Technical Review Committee

**CITY OF DELAND
THURSDAY MARCH 20, 2025 AT 1:30 P.M.
CITY OF DELAND TRC MEETING ROOM
DELAND, FLORIDA**

City of DeLand
SP24-198
DUPONT
WAREHOUSE

City of DeLand
SP25-007
HULLEY TOWER,
STETSON

City of DeLand
SP25-021
THE TOWNS AT SUMMIT
AMENITY SITE

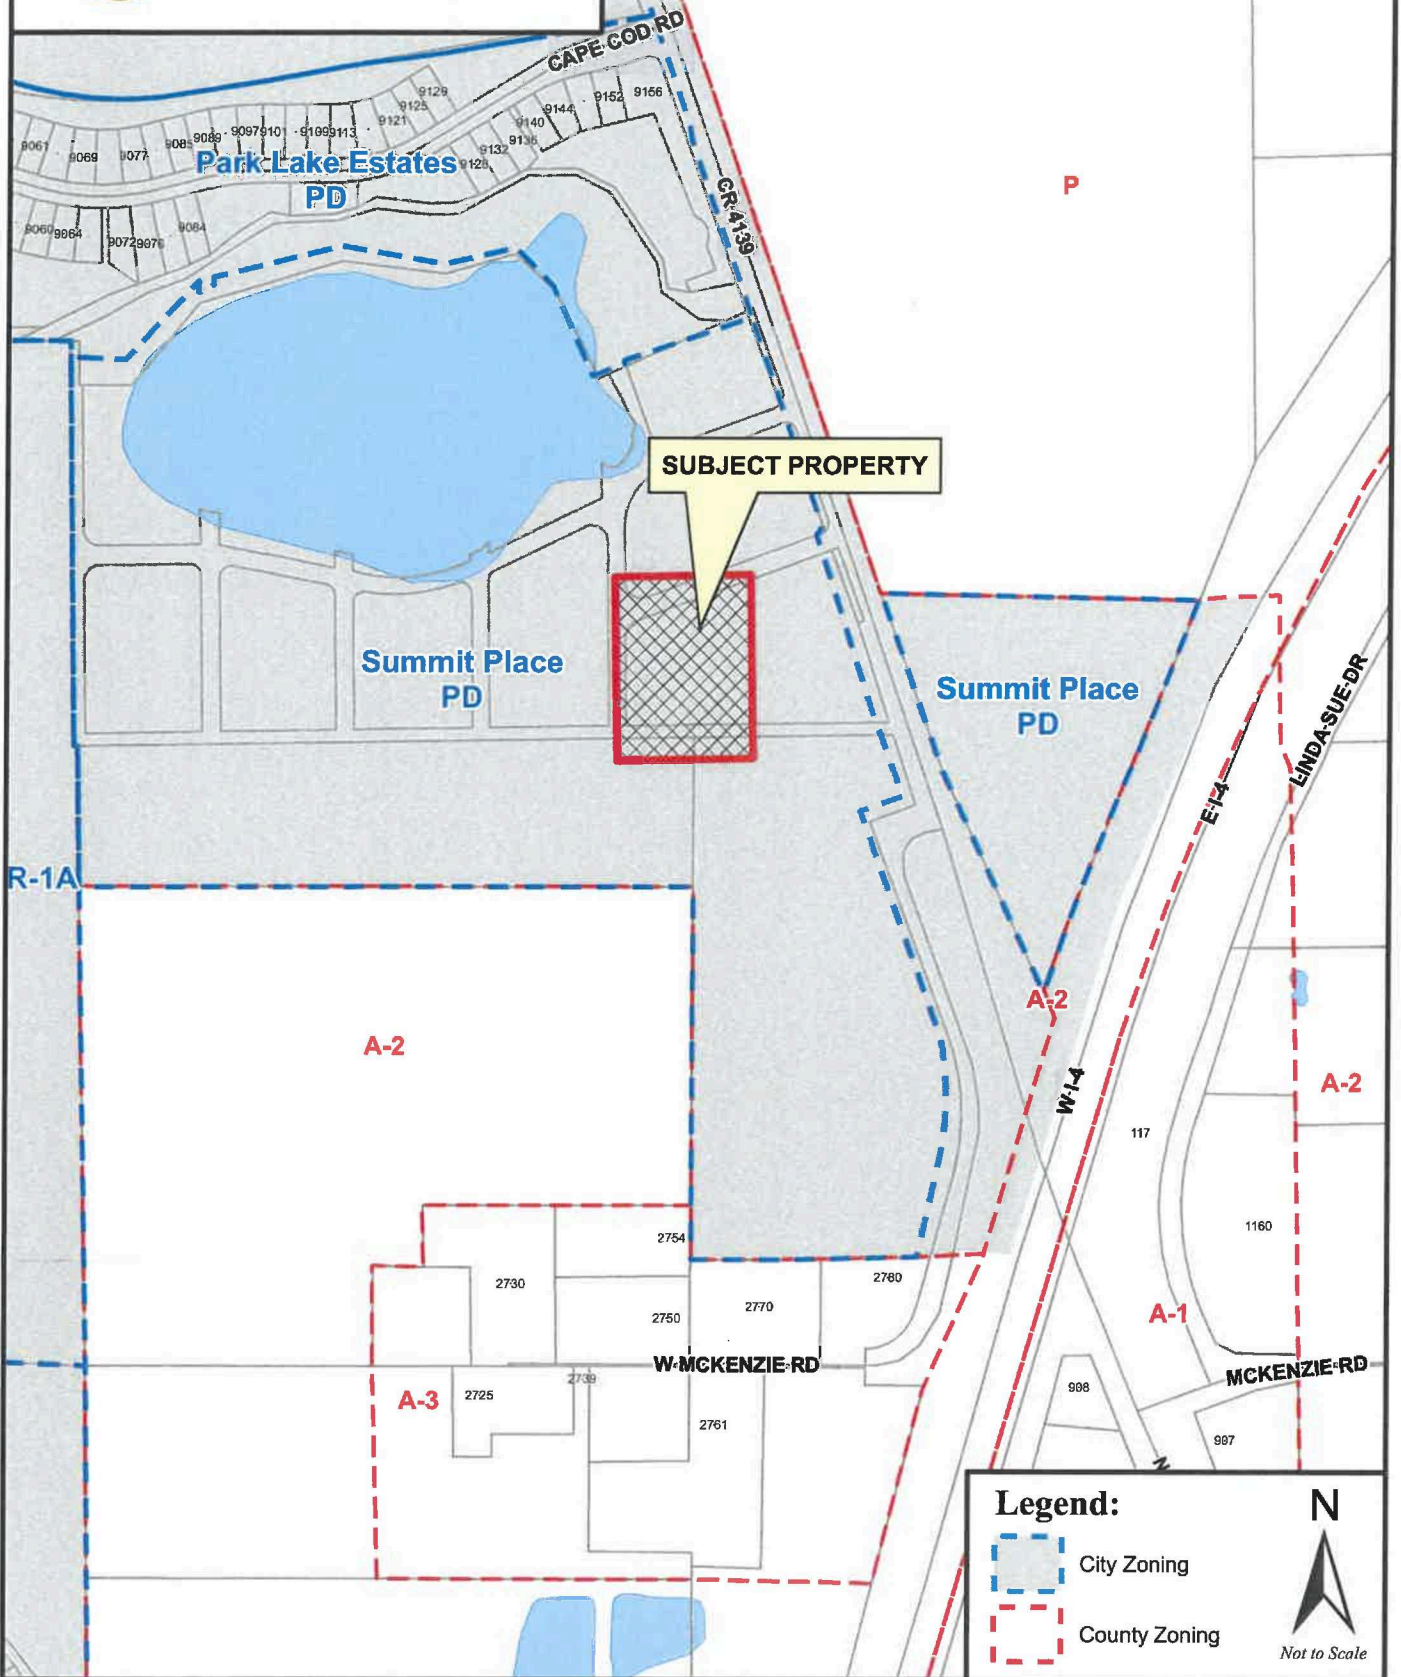
Discipline	Status	Details	Attached To	Created By	Last Updated By	Modifications Required
Engineering	Draft	Drainage 1. It would appear that a junction box or other structure is necessary between YD12 and YD17 to facilitate the connection of the storm piping.	C3.0	Steven Danskine	Steven Danskine	Yes
Forestry	Draft	Note 2. a. Add " and City Forester" to the end of the note.	L1.51	Kit Dennis	Kit Dennis	Yes
Forestry	Draft	Tree Protection Fencing Please replace the Tree Protection Fencing detail with the City's Typ Tree Barricade Detail. It can be found on our website.	L1.50	Kit Dennis	Kit Dennis	Yes
Forestry	Draft	Magnolias The original approved landscape plan for the development shows 4 Magnolia trees being installed on the west side of this site. Are the Magnolias still being planted on site? If they have been relocated, please indicate where they can be found.	L1.00	Kit Dennis	Kit Dennis	Yes
Forestry	Draft	Bald Cypress You are showing the relocation of 13 Bald Cypress trees that were part of the approved overall landscape plan. I assume these changes are tied to the revision submitted as PSB23-029.002. That revision has yet to be approved as Forestry still has an open comment regarding landscape modifications. You are showing a total of 18 Bald Cypress trees on this plan. The original approved plan had 22. Please show where the four missing Bald Cypress trees are being relocated to.	L1.00	Kit Dennis	Kit Dennis	Yes

Forestry	Draft	Palm Trees Ribbon Palm is not on our approved species list and will not count towards minimum coverage requirements. We have added Roebelenii to our list as an understory tree. However, it would need to meet the minimum height requirement of 8' overall height.	L1.00	Kit Dennis	Kit Dennis	Yes
Forestry	Draft	Minimum Tree Coverage At 23,579 sqft, this site requires 9 trees. Your plan currently provides 8 trees that are from our approved species list. You will need to add an additional tree to the site.	L1.00	Kit Dennis	Kit Dennis	Yes

Discipline	Status	Details	Attached To	Created By	Last Updated By	Modifications Required
Forestry	Draft	Tree Specifications In order to meet Grade 1 standards for the specified calipers, the following specs will need to be corrected: - Southern Live Oak - 8' HT, 4' Spread - Japanese Blueberry - 9' HT, 2.5' Spread - Grape Myrtle - 7' Spread	L1.00	Kit Dennis	Kit Dennis	Yes
Forestry	Draft	Trees and Vegetation Notes You also have Trees and Vegetation notes on sheet C1.0. Please consolidate the notes. Right now, they provide conflicting information.	C1.1	Kit Dennis	Kit Dennis	Yes
Forestry	Draft	Trees and Vegetation Note 1 This note refers to sheet C2.1. I do not see a sheet C2.1. It also refers to protecting trees with "wood fencing." Please correct the note to refer to sheet L1.50. The Detail on sheet L1.50 will need to be replaced with the City's Typ Tree Barricade Detail.	C1.0	Kit Dennis	Kit Dennis	Yes

Planning	Draft	Fencing Is there proposed fencing around the site? If so, provide the details and location	C2.0	Emily Ragusa	Emily Ragusa	Yes
Planning	Draft	Colors and Materials Include the proposed colors and materials for the pool cabana.	A3	Emily Ragusa	Emily Ragusa	Yes
Planning	Draft	Vertical Elements Include additional vertical elements to break up the blank wall such as faux window, banding, vertical columns.	A3	Emily Ragusa	Emily Ragusa	Yes
Planning	Draft	Photometric Plan Illumination from any light source onto adjacent properties or into the public right-of-way shall not exceed 0.5 foot-candles. (LDR Sec. 33-94.03(g)(2)	L4.00	Emily Ragusa	Emily Ragusa	Yes
Planning	Draft	Pool Shower Show the location of the pool shower on the plans	C2.0	Emily Ragusa	Emily Ragusa	Yes
Planning	Draft	Pool Cabana Dimensions Provide the dimensions of the pool cabana building	C2.0	Emily Ragusa	Emily Ragusa	Yes

Planning	Draft	Mechanical/Pool Equipment Show on the site plan the location of the mechanical and pool equipment and ensure it is screened per LDR Sec. 33-94.03(a)(4) Also add a sheet reference note for proposed screening	C2.0	Emily Ragusa	Emily Ragusa	Yes
Planning	Draft	Community Name Add the community name to all the sheets	C1	Emily Ragusa	Emily Ragusa	Yes

City of DeLand
FSB25-022
YARDLY DELAND CROSSING
FINAL PLAT

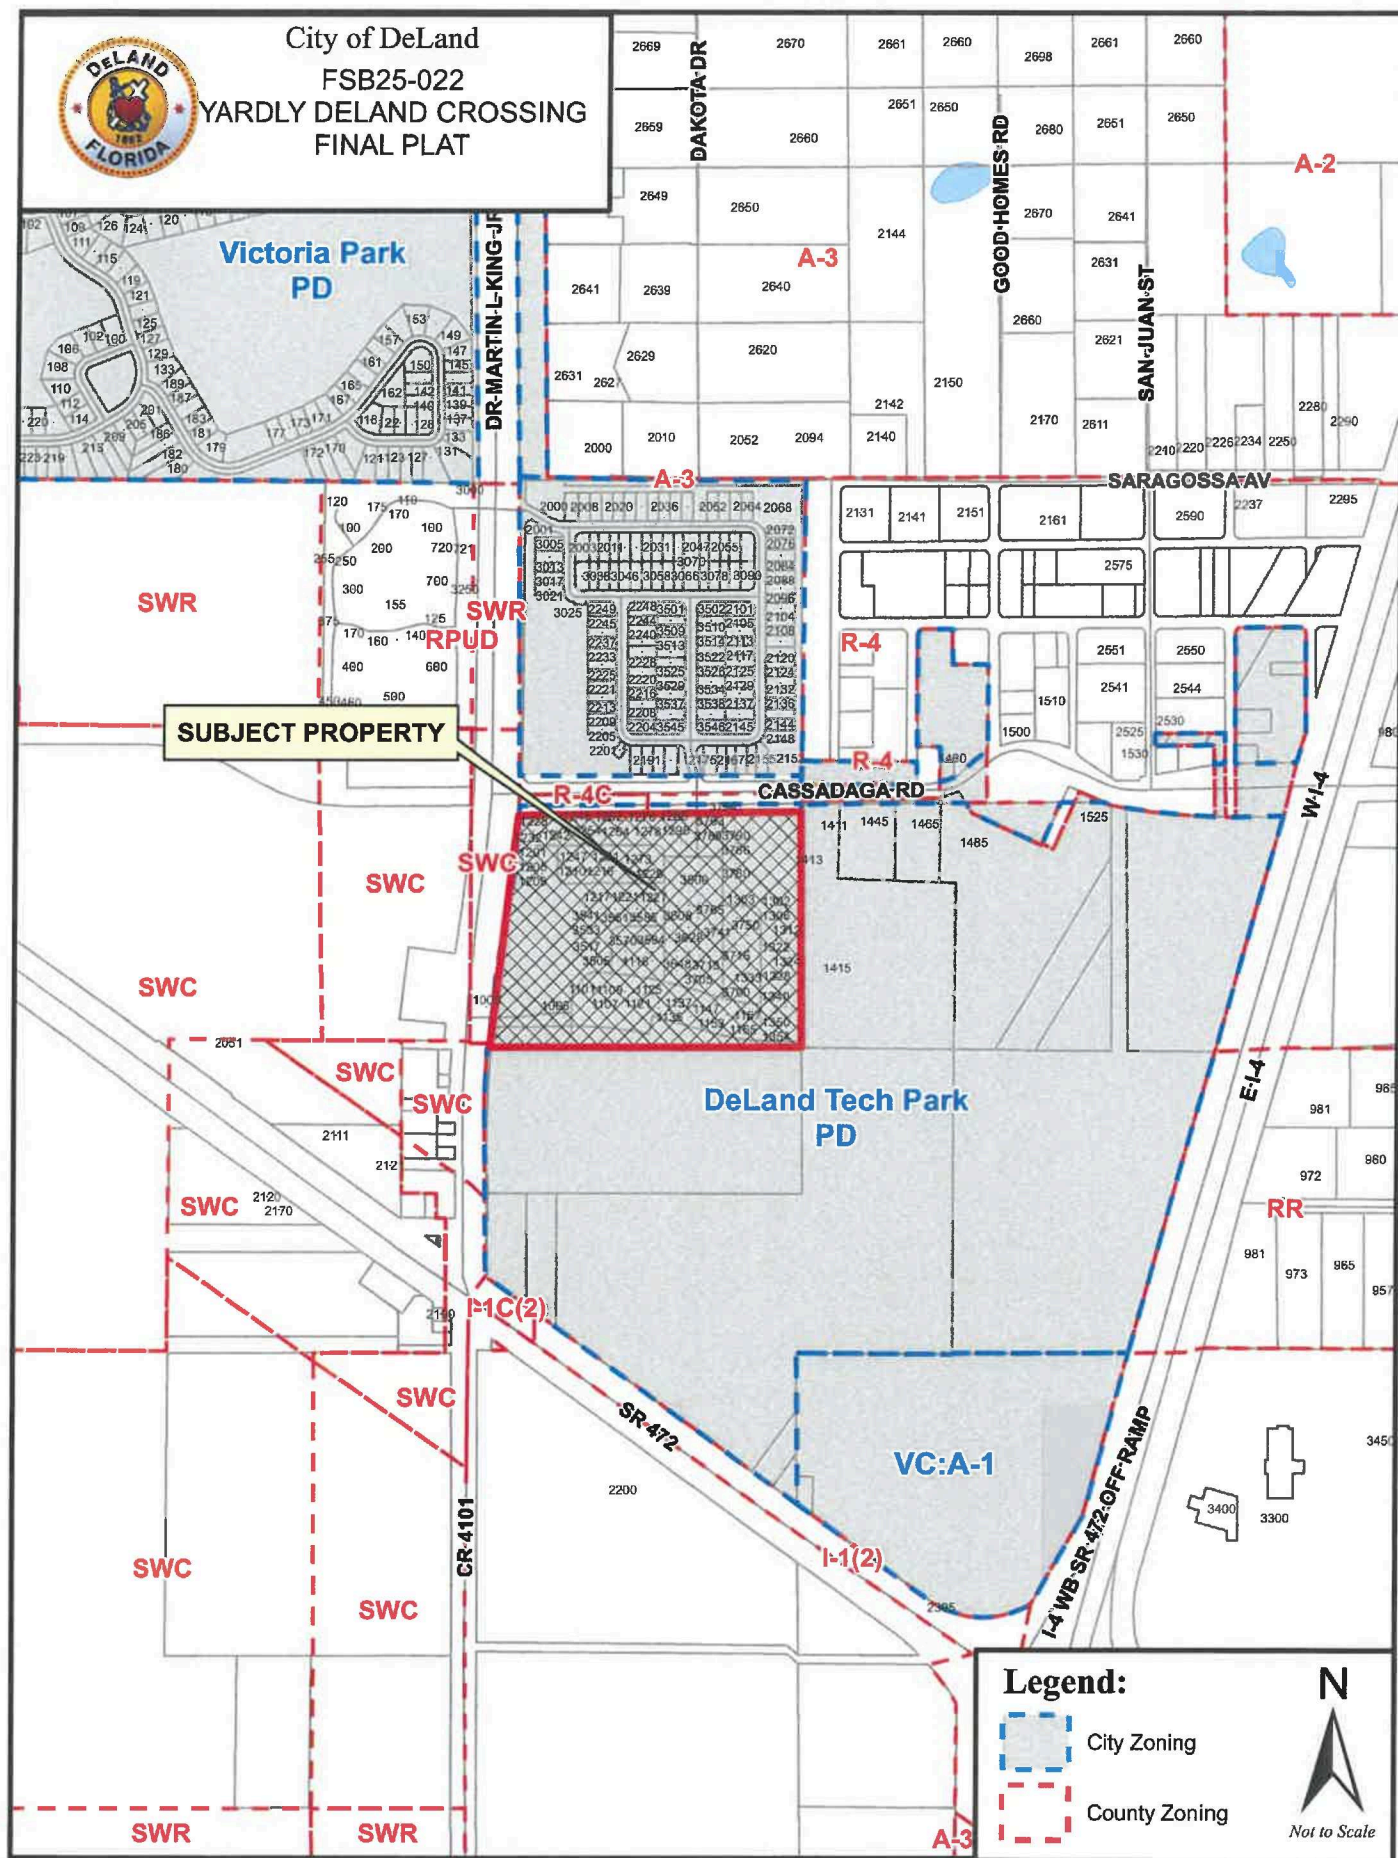
Discipline	Status	Details	Attached To	Created By	Last Updated By	Modifications Required
Forestry	Draft	Tree Protection Area Tracts The Tree Protection Areas must be placed in tracts.	SHEET 2	Kit Dennis	Kit Dennis	Yes
Planning	Draft	Street name Verify that the street names have been approved by Volusia County.	SHEET 2	Belinda Collins	Belinda Collins	Yes
